To: T10 Technical Committee
From: Barry Olawsky, HP (barry.olawsky@hp.com) and Rob Elliott, HP (elliott@hp.com)
Date: 26 February 2007
Subject: 07-083r0 SAS-2 Mini SAS 4i to SAS 4i cable assemblies with SGPIO

Suggested changes to SAS-2

Figure 1 — SAS internal symmetric cable environment - controller to controller

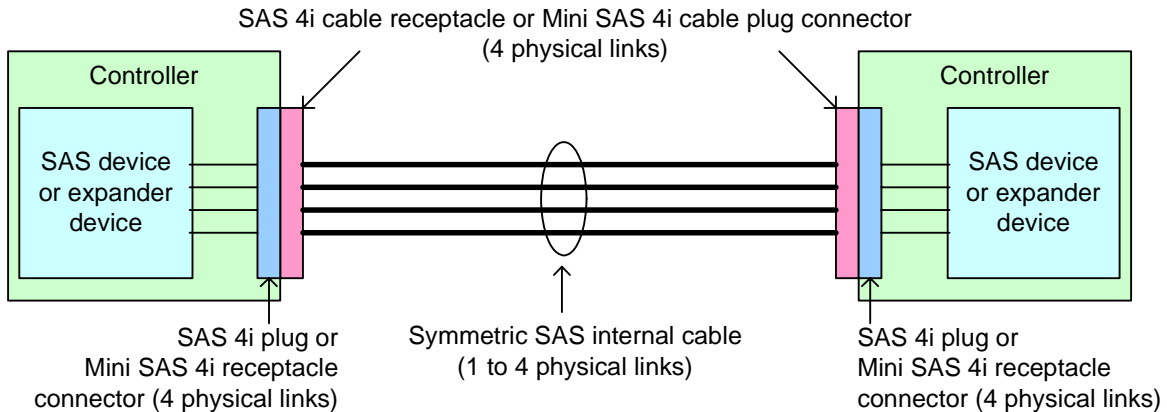
Figure 1 shows a schematic representation of the SAS internal cable environment attaching a controller to a controller using a SAS internal symmetric cable. Two controllers may also be attached together with a SAS internal symmetric cable. ~~If SAS 4i connectors are used, all four physical links are used (see 5.2.4.1.1).~~

Figure 4 — SAS internal symmetric cable assembly - SAS 4i to Mini SAS 4i [generic](#)

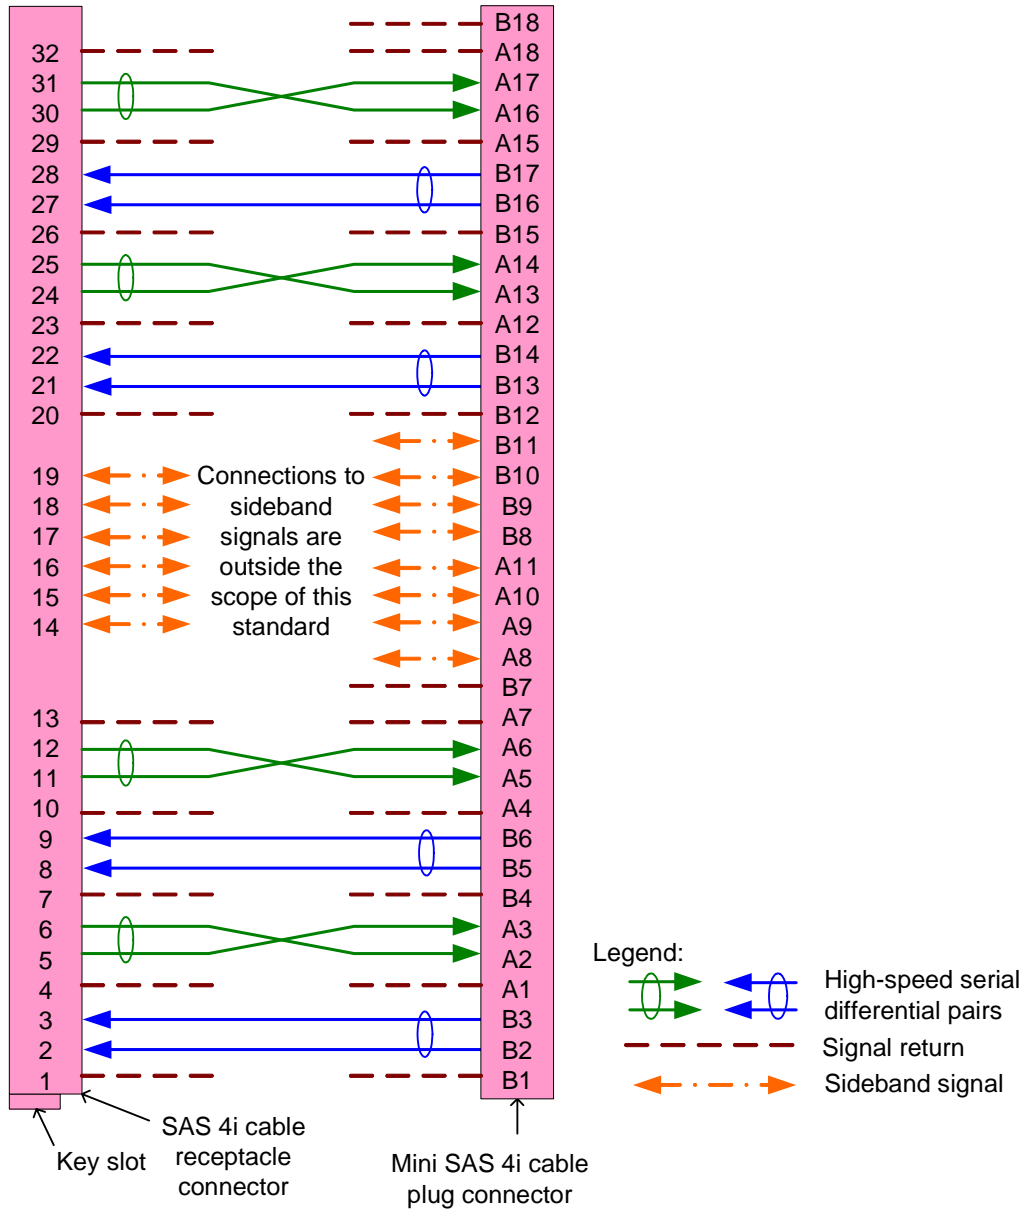
Figure 4 shows the SAS internal symmetric cable assembly with a SAS 4i cable receptacle connector at one end and a Mini SAS 4i cable plug connector at the other end. [Which side is used for the controller is not specified.](#)

NOTE 1 - The cable assembly needs different SIDEBAND signal routing based on whether the controller or backplane is using the SAS 4i connector.

For controller-to-backplane applications with the Mini SAS 4i cable receptacle connector on the controller end, the cable assembly shall support all four physical links and the controller should use all four physical links,

because the controller's physical links 0, 1, 2, and 3 are attached to the backplane's physical links 3, 2, 1, and 0, respectively. If both controllers use one or two physical links starting with physical links 0, communication is not possible. If both controllers use physical links 0, 1, and 2, then only communication over physical links 1 and 2 is possible.

Figure 5 — SAS internal symmetric cable assembly - SAS 4i controller to Mini SAS 4i backplane with SGPIO

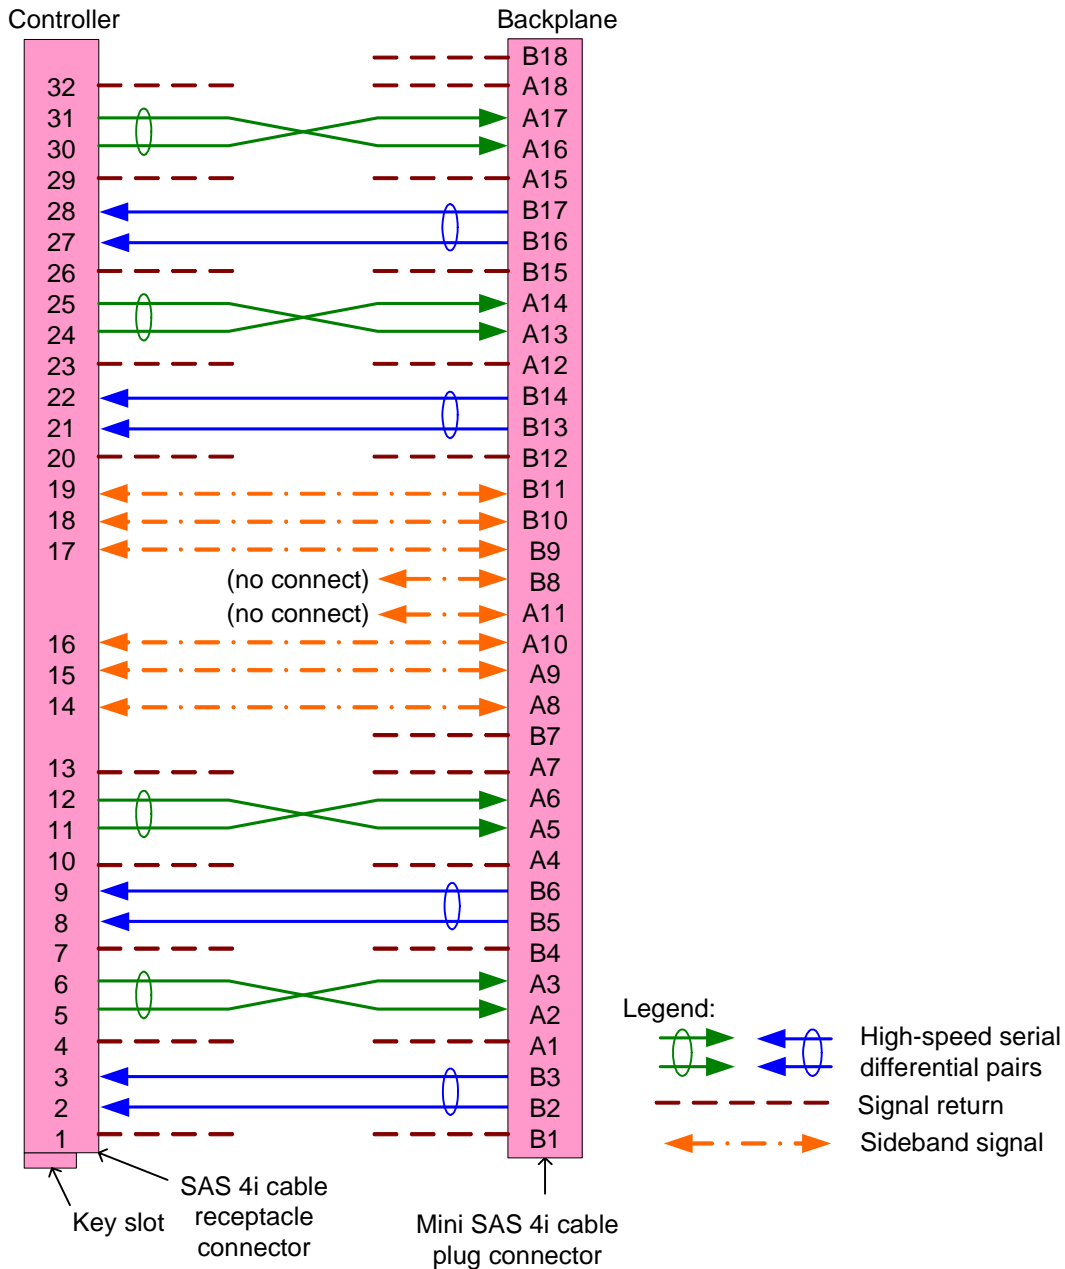
Figure 4 shows the SAS internal symmetric cable assembly with a SAS 4i cable receptacle connector at the controller end and a Mini SAS 4i cable plug connector at the backplane end, with sidebands connected to support SGPIO (see SFF-8485).

The cable assembly shall connect each signal return on one end to at least one signal return on the other end. The cable assembly may connect one or more of the signal returns together.

The cable assembly may support one to four physical links.

Figure 6 — SAS internal symmetric cable assembly - Mini SAS 4i controller to SAS 4i backplane with SGPIO

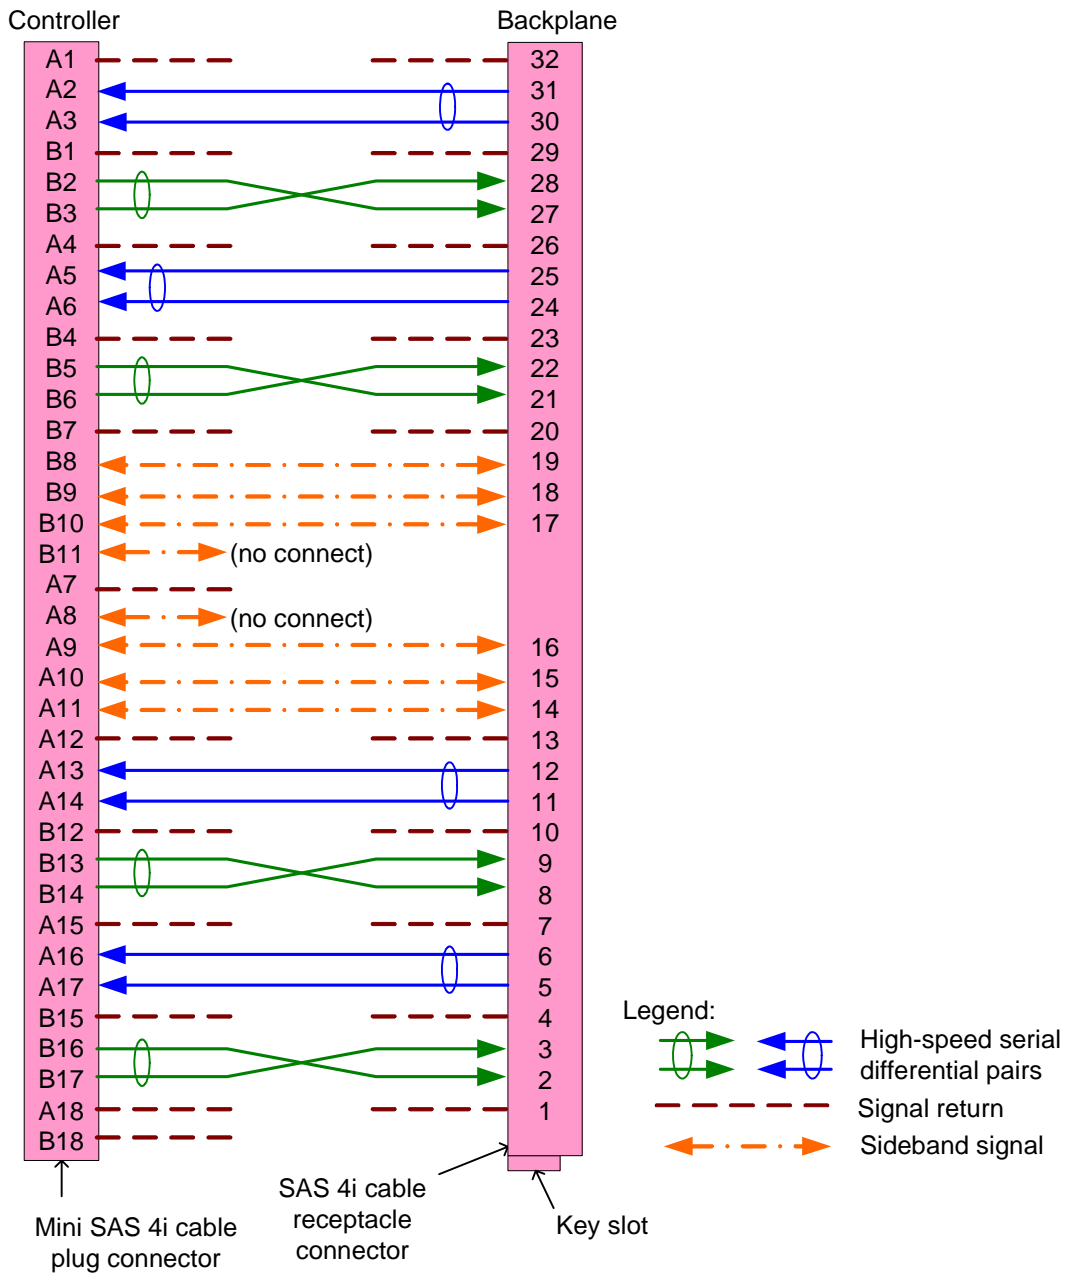
Figure 4 shows the SAS internal symmetric cable assembly with a Mini SAS 4i cable receptacle connector at the controller end and a SAS 4i cable plug connector at the backplane end, with sidebands connected to support SGPIO (see SFF-8485).

The cable assembly shall connect each signal return on one end to at least one signal return on the other end. The cable assembly may connect one or more of the signal returns together.

The cable assembly may support one to four physical links.
